STATE OF MICHIGAN
DEPARTMENT OF MANAGEMENT AND BUDGET **December 5, 2008**
PURCHASING OPERATIONS
P.O. BOX 30026, LANSING, MI 48909
OR
530 W. ALLEGAN, LANSING, MI 48933

CHANGE NOTICE NO. 35
TO
CONTRACT NO. 071B5000240
between
THE STATE OF MICHIGAN
and

Effective immediately, the attached Statement of Work for the MPSCS System Upgrade to ASTRO 6.9 is hereby incorporated into this contract. All other Terms, Conditions, Specifications and pricing remain the same.

ASTRO® 25 IP Platform with the Voice feature architecture

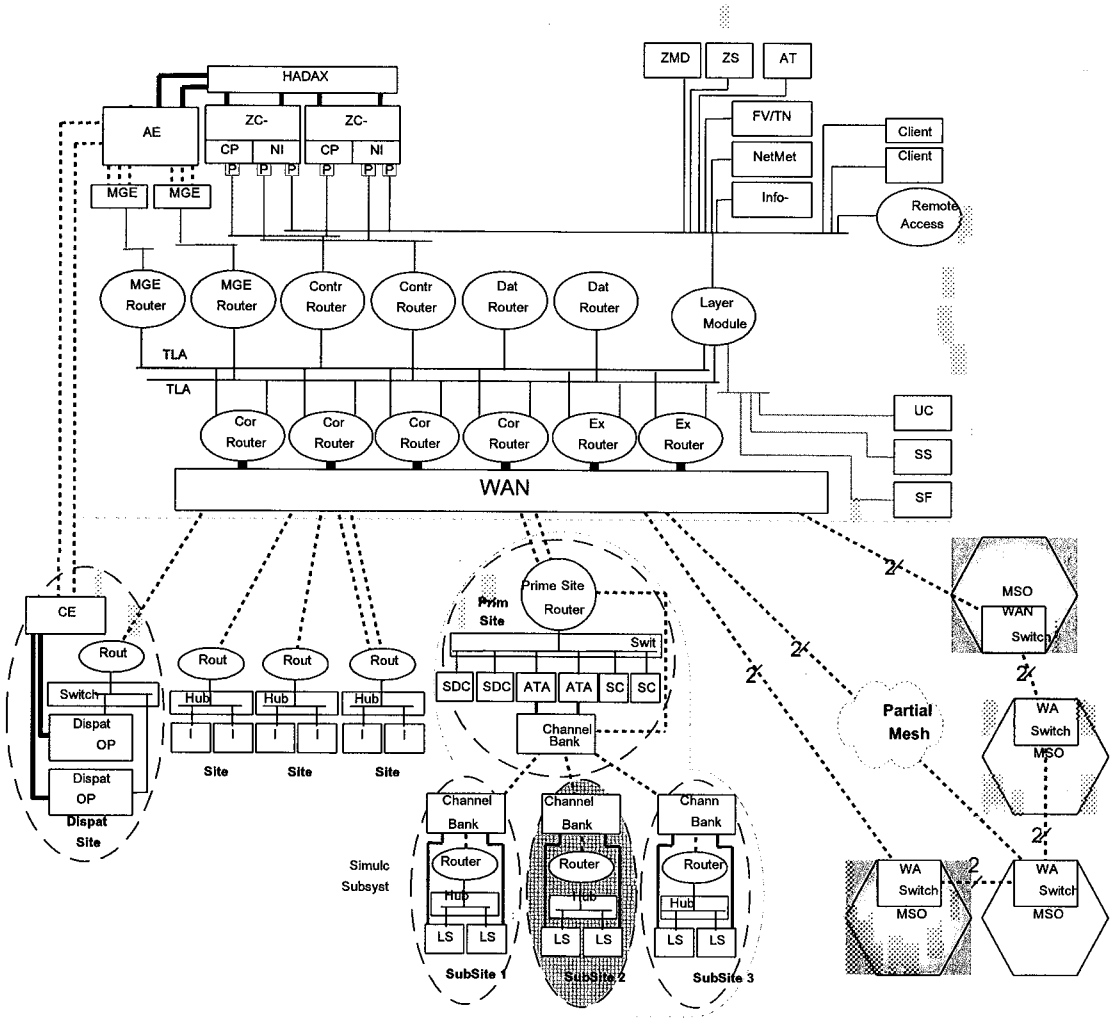
58) In Exhibit A, Section 2.3., Wide Area Operation, delete " Figure 2.3 System Block Diagram" and paragraphs six through thirteen and add "Figure 2.3 A ASTRO® 25 IP Platform with the Voice feature architecture.

Figure 2.6.5.1

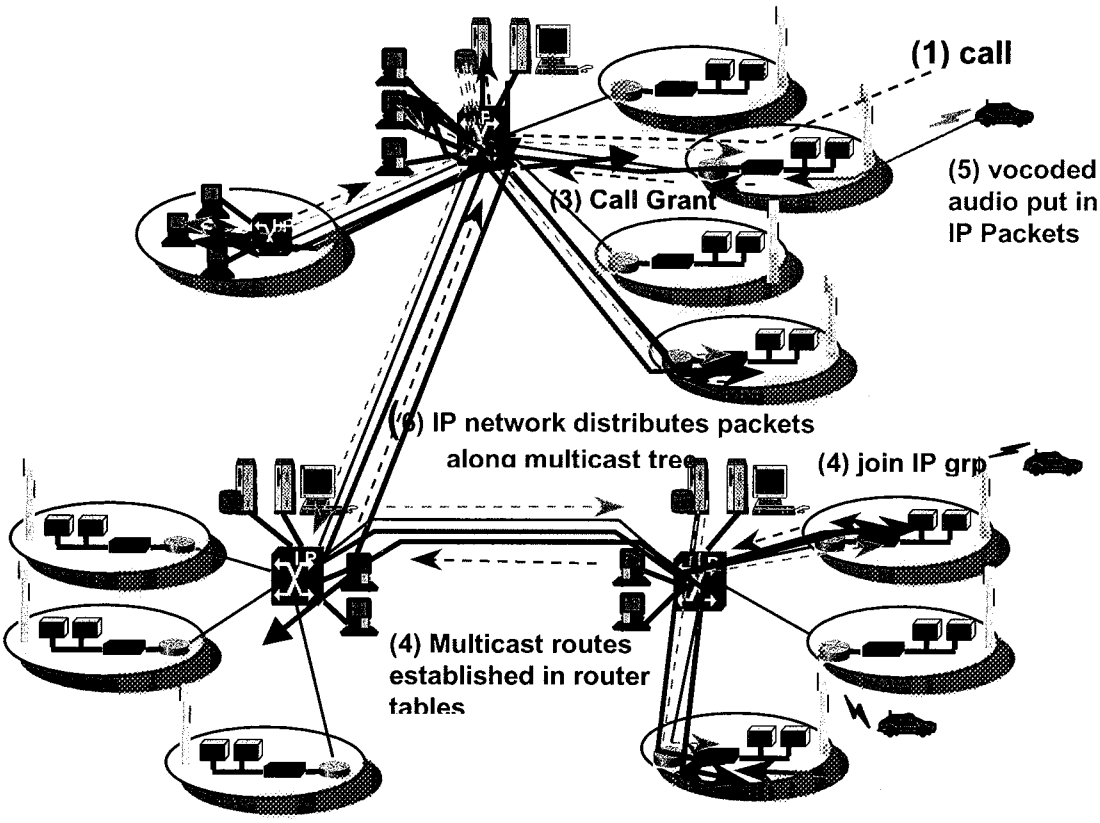
2.6.5.1 Voice (Unit to unit)Overview of an ASTRO 25 Talkgroup Voice Call Using IP Multicast: (see Figure 2.6.5.1)

ASTRO® 25 IP Platform
with the Voice feature Transport Drawing

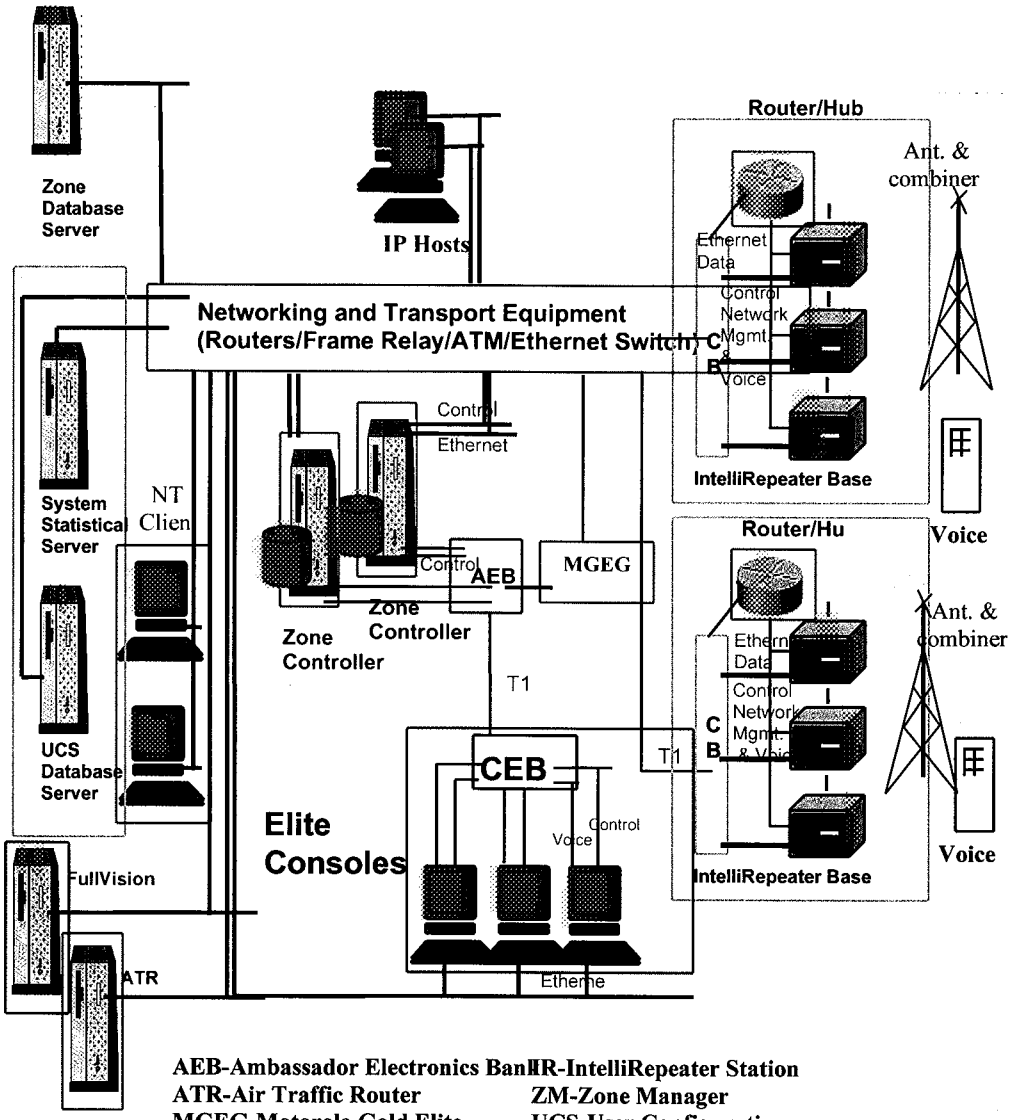
See Drawing below titled: ASTRO® 25 IP Platform with the voice feature Transport Drawing
